Wisconsin Department of Transportation

Proposal #20: 1130-68-77, WISC 2025473
Appleton - De Pere
Sbc Interchange
Loc Str
Brown County

This is Addendum No. 01, which provides for the following:

ADDENDUM NO. 01

Addendum No. 01
ID 1130-68-77
Revised Sheet 8
April 28, 2025

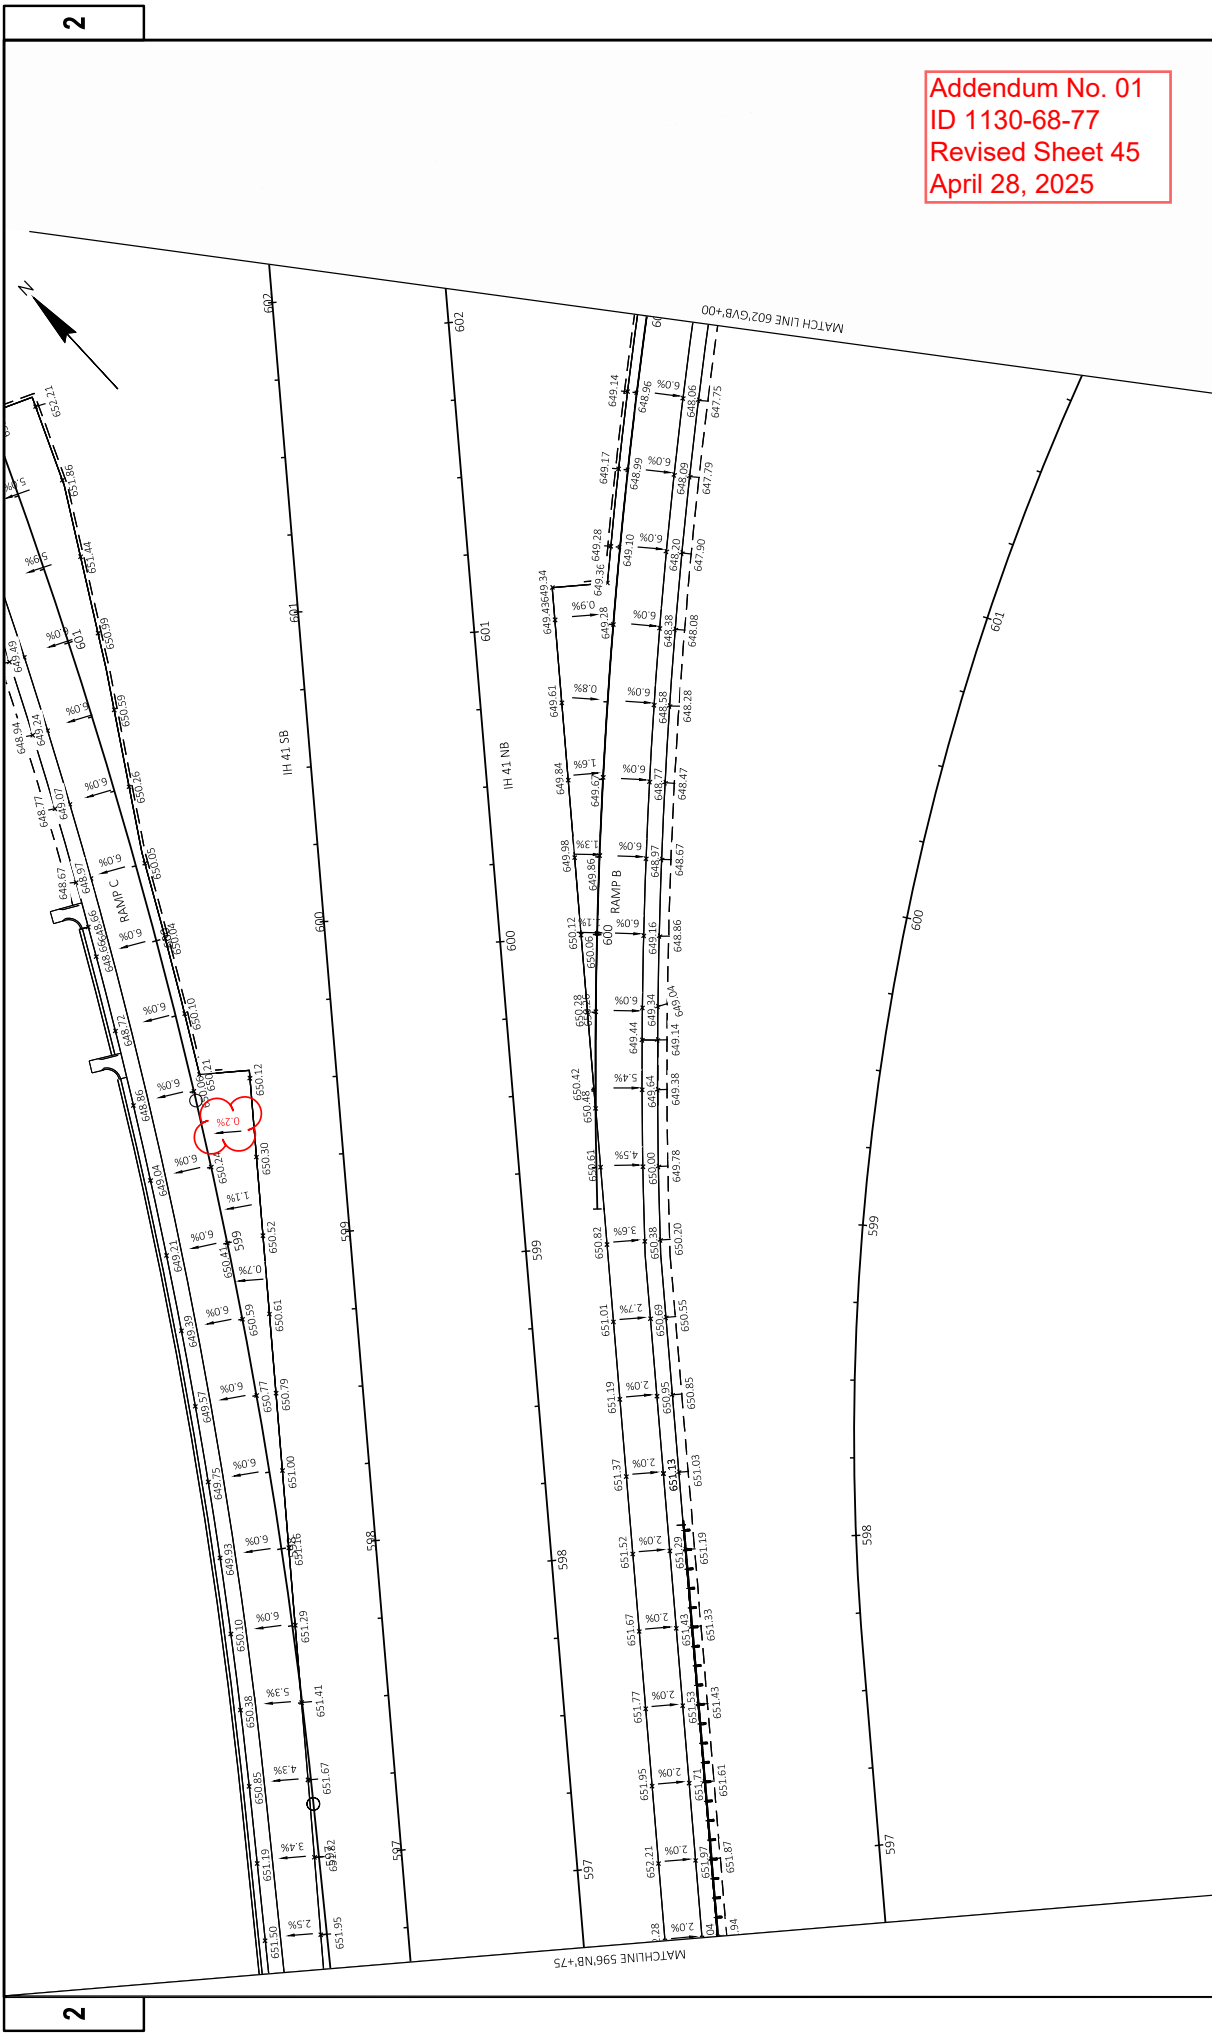
Revised Plan Sheets	
Plan Sheet	Plan Sheet Title (brief description of changes to sheet)
8	Typical Sections – Replaced “Concrete Curb & Gutter 4-Inch Sloped 36-Inch Type R” to “Concrete Curb & Gutter 4-Inch Sloped 30-Inch Type R” for roundabout circulator
17	Construction Detail – Revised pedestrian curb from 6-inch curb head to 12-inch curb head
45,51,54	Intersection Details – Add missing pavement grades
57	Intersection Details – Revised pavement grades, revised linework at Foth Driveway
64, 67-69	Removals – Add Removing Fence
72	Plan Detail Legend – Added “Concrete Curb & Gutter 4-Inch Sloped 30-Inch Type R”, Replaced “Concrete Curb & Gutter 4-Inch Sloped 36-Inch Type R” with “Concrete Curb & Gutter 4-Inch Sloped 36-Inch Type A”, Revised Curb Ramp Detectable Warning Field and Radial items from “Yellow” to “Natural Patina”, Removed “Concrete Median Blunt Nose” item

Addendum No. 01
ID 1130-68-77
Revised Sheet 75
April 28, 2025

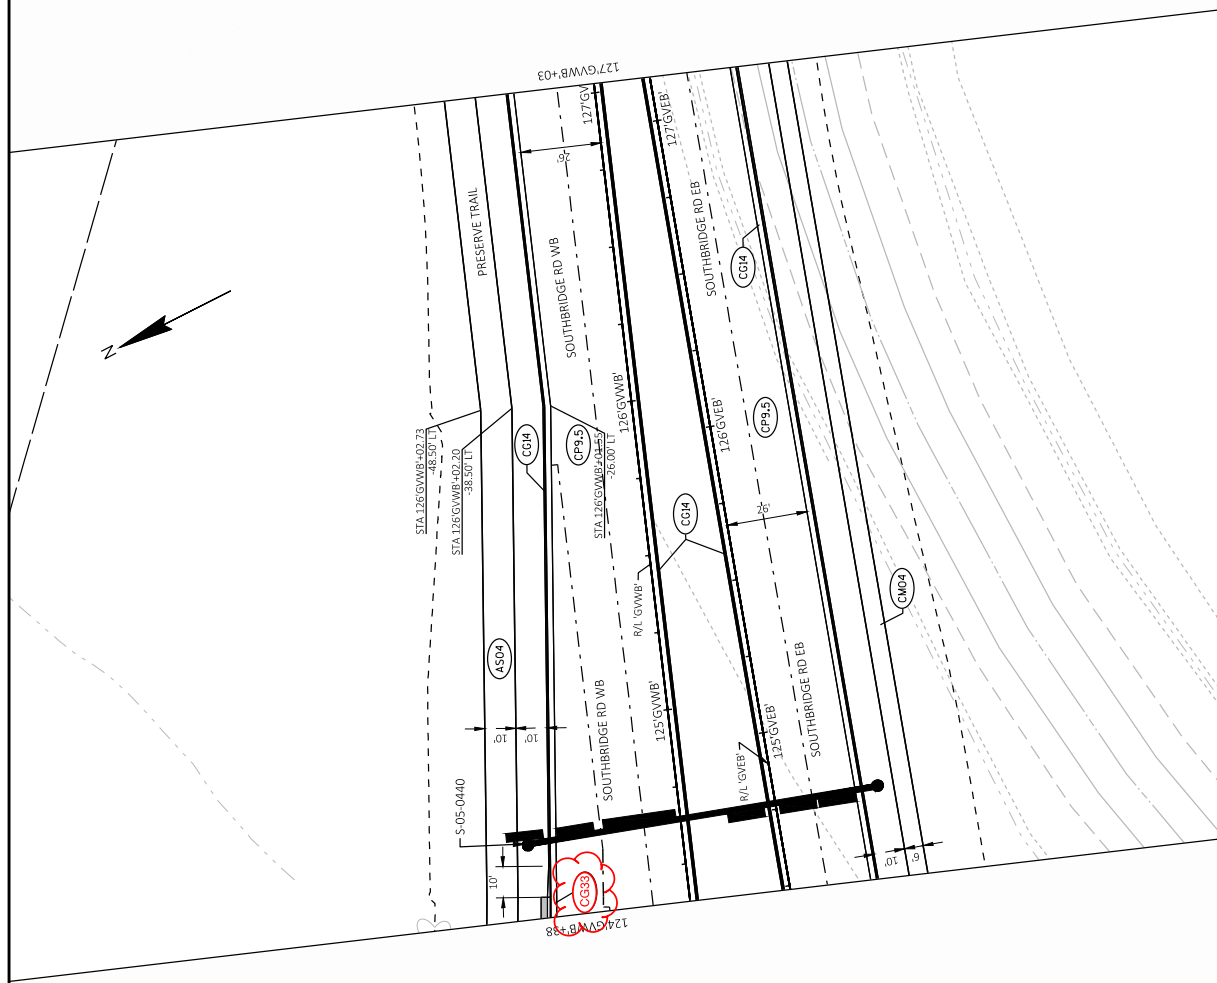
75-78,80,88	Plan Details – Replaced “Concrete Curb & Gutter 4-Inch Sloped 36-Inch Type R” to “Concrete Curb & Gutter 4-Inch Sloped 30-Inch Type R” for roundabout circulators, replaced “Concrete Median Blunt Noses” with “Concrete Median Slope Nose”, replaced “Concrete Curb & Gutter 36-Inch Special” with “Concrete Curb & Gutter 4-Inch Sloped 36-Inch Type A” in areas with truck tracking pavement. Replaced “Concrete Curb & Gutter 30-inch Type D” with “Concrete Curb & Gutter 36-Inch Special” in areas with a paved median.
94	Plan Details – Revised Station & Offsets to match into existing Foth Driveway
178	Permanent Signing: Add removal of existing Exit sign at STA 602+37NB, RT
252-253	Traffic Control – Replaced “Flexible Delineator” in Stage 3B Legend with “Delineator Flexible/Tubular Marker”
317	Miscellaneous Quantities – Revised concrete quantities: Truck Apron, Coloring Concrete Red, and Median Sloped Nose

Addendum No. 01
ID 1130-68-77
Added Sheet 512A
April 28, 2025

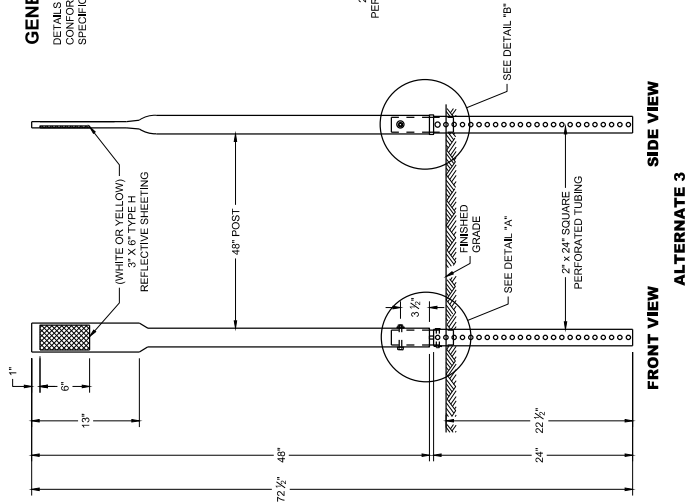
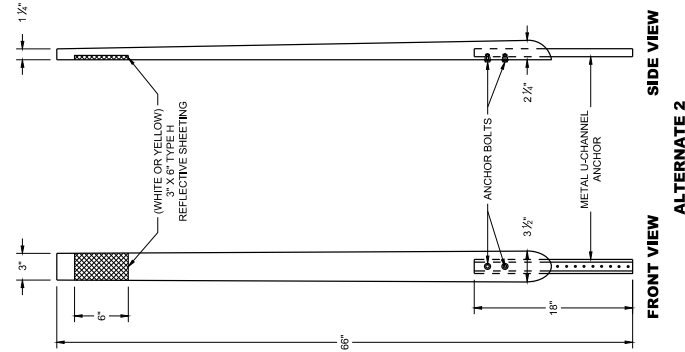
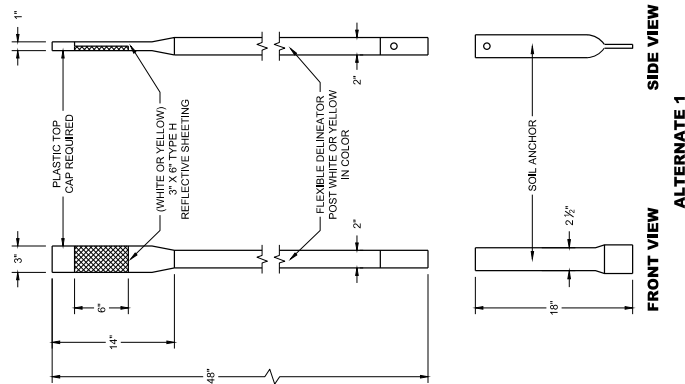
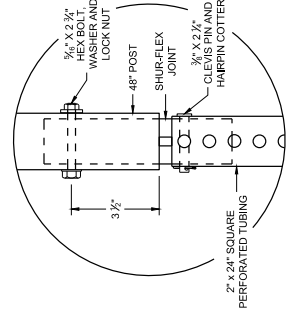
Added Plan Sheets	
Plan Sheet	Plan Sheet Title (brief description of why sheet was added)
289A	Fencing Plans – Shows added fence for connection between fence and barrier wall
512A-512E	Standard Detail Drawings – Add 15A04-08a-e for Delineators

Addendum No. 01
ID 1130-68-77
Revised Sheet 671
April 28, 2025

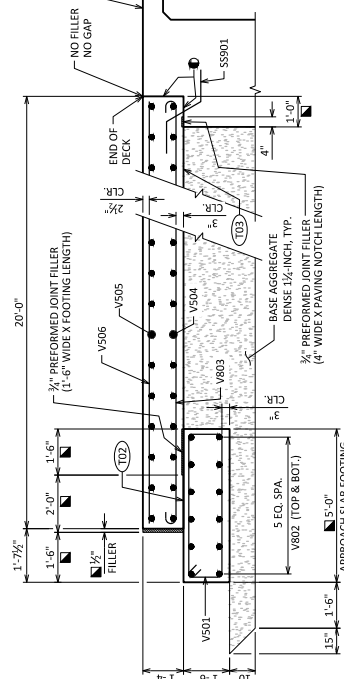
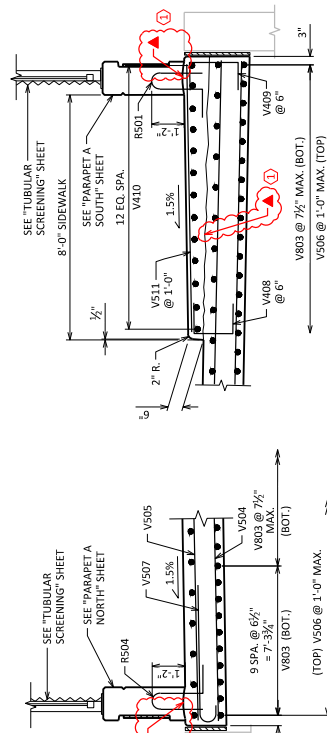
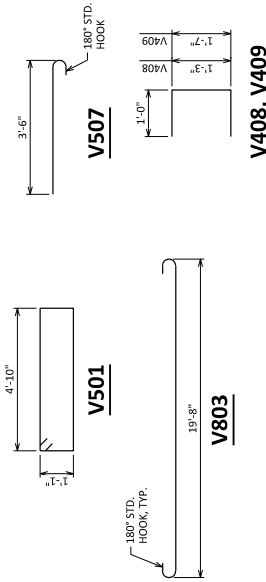
①	4/11/2025	CONST. JOINT & SYMBOL CALLOUT	WWW
---	-----------	-------------------------------	-----
